**RE: Response to Back River Project Type A Water Licence Technical Comments (2AM-BRP----**

The **BACK RIVER**  
**PROJECT**

**TYPE A WATER LICENCE  
TECHNICAL COMMENT RESPONSES**

April 2018  
NWB File No. 2AM-BRP----

Figure 3.4-8 from Appendix V6-6D of the Final Environmental Impact Statement

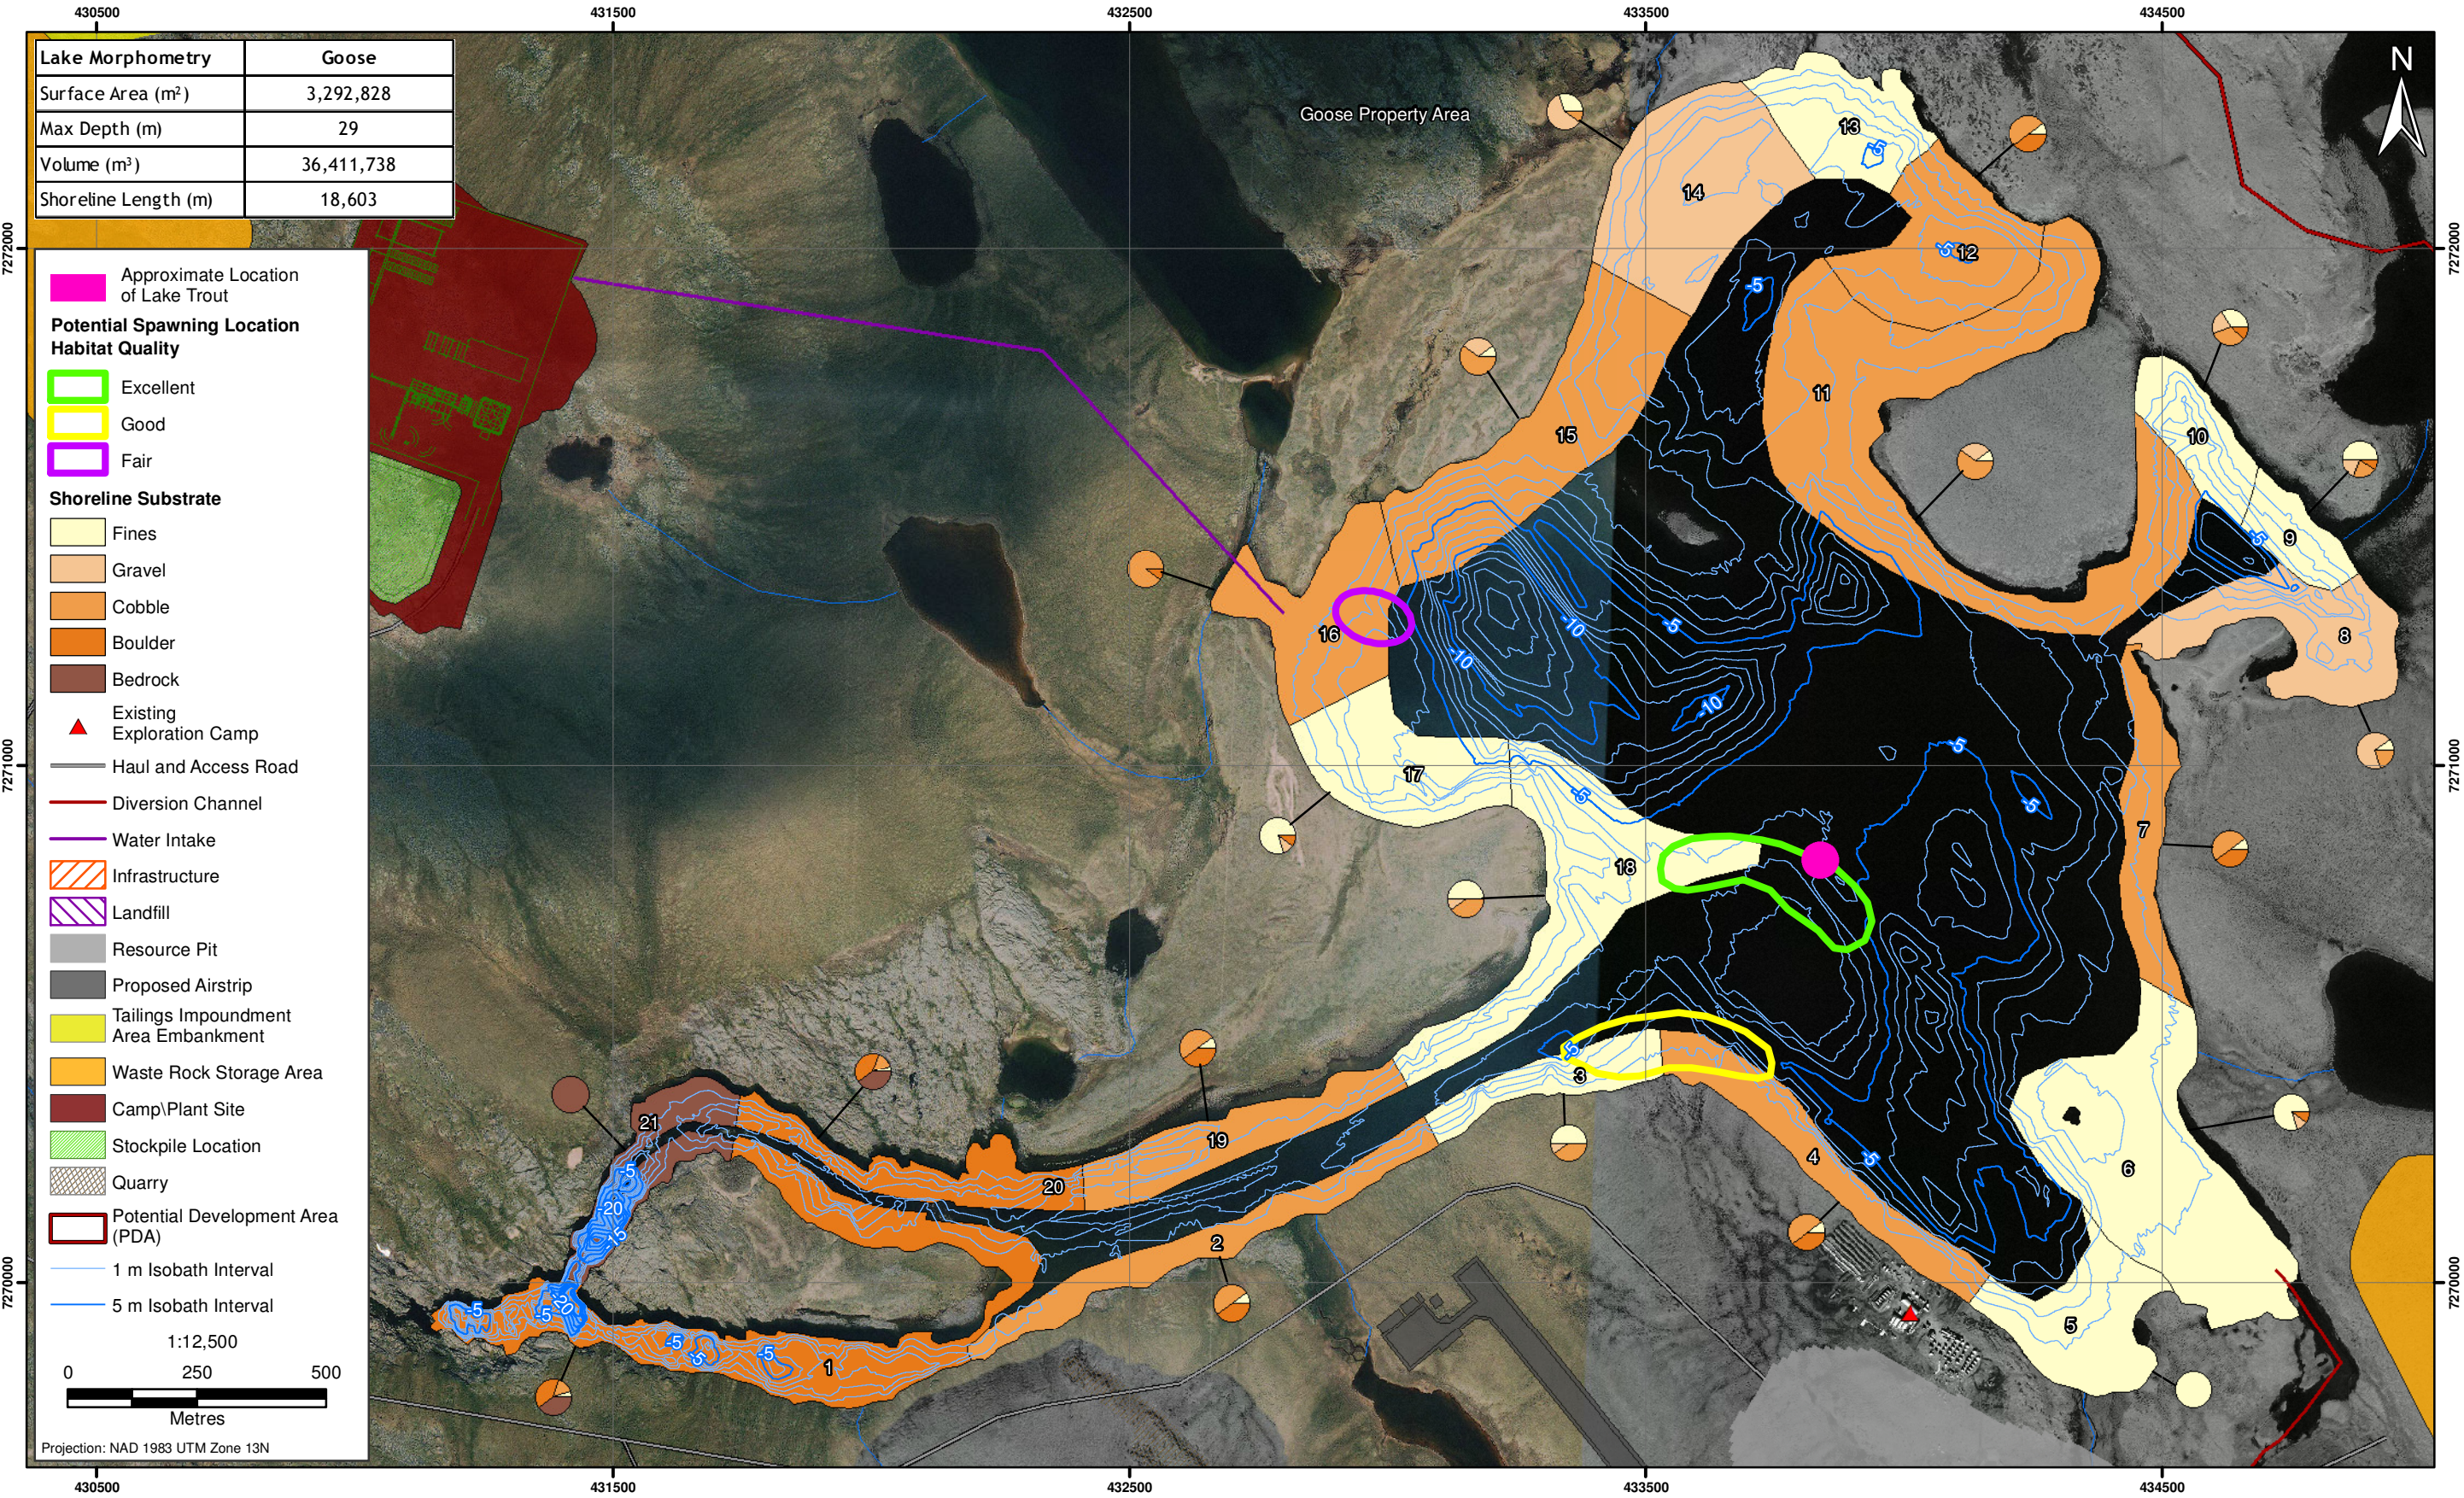
If the recommended setback distances are approached, then site-specific operating mitigation could be implemented to protect fish if required. For example, if necessary, it may be possible to adjust blasting practices during the time of highest biological sensitivity (i.e., the window of early development for eggs of Lake Trout and Lake Whitefish) or to use controlled blasting techniques. As shown in Figure 3.4-8 in Appendix V6-6D of the Final Environmental Impact Statement (attached), there are no nearby spawning beds in Goose Lake. Furthermore, several studies have demonstrated that exposure to a blast that generates up to 28.5 mm/s (expected at Goose Main Pit), egg mortality would be minimal as eggs are resilient to effects from vibrations within this range (Faulkner et al. 2006, 2008). In addition, potential effects on overpressure and vibrations are reduced as the pit depth increases.
